Advice on Groundwater Management and Monitoring and
Groundwater Dependent Ecosystem Management plans to the
Department of the Environment and Energy

The Department of the Environment and Energy requested CSIRO and Geoscience Australia to assess draft research and management plans submitted by Adani Pty Ltd for the Carmichael Coal Project under *Environment Protection and Biodiversity Conservation Act* (1999) approval conditions (EPBC ref: 2010/5736). This advice addresses questions for the Groundwater Dependent Ecosystem Management Plan (version 10a) and the Groundwater Management and Monitoring Plan (version 5).

Groundwater Dependent Ecosystems Management Plan (GDEMP) for the Carmichael Coal Mine

Figure 1. Spatial distribution of off-lease monitoring bores. Note that some locations represent nested bore sites. The green polygon shows the Proponent's mining lease areas.

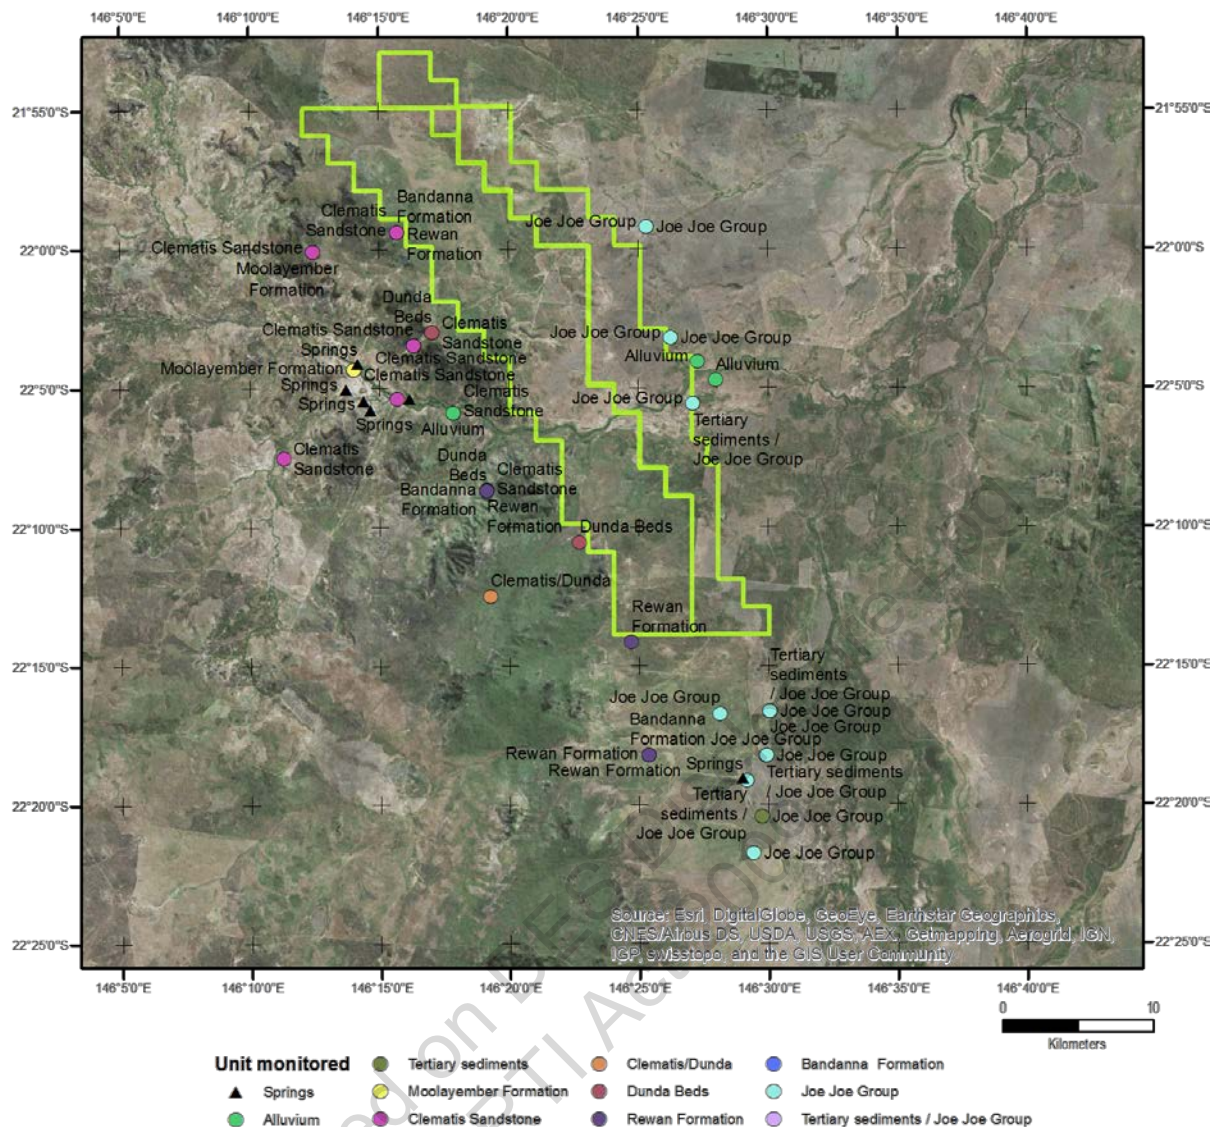
The monitoring network set out in the GMMP is designed to monitor potential impacts to the DSC based on the conceptualisation that the springs are sourced solely from the Clematis Sandstone. The distribution of monitoring bores is not adequate if other units provide a direct source to the DSC, or through the Clematis Sandstone to the DSC, either by transmission through interconnectivity of hydrostratigraphic units or via structural pathways (not limited to geological faults). The GMMP monitoring network does not provide adequate spatial or geological unit coverage to monitor for groundwater impacts if aquifers other than the Clematis Sandstone contribute flow to the DSC. This effectively means that the proposed GMMP monitoring network will only be able to identify potential impacts that may affect the DSC where they are evident in a source aquifer in the Clematis Sandstone.

In the GMMP, there are 54 off-lease monitoring bores (Table 1 and Figure 1 below). The off-lease monitoring bores are primarily designed to monitor the Joe Joe Group and the Clematis Sandstone. These are the source aquifers proposed by the proponent for the Mellaluka Springs and DSC respectively. The monitoring network set out in the GMMP for the Mellaluka Springs appears adequate, given that these are sourced from the Joe Joe Group and Tertiary¹ sediments.
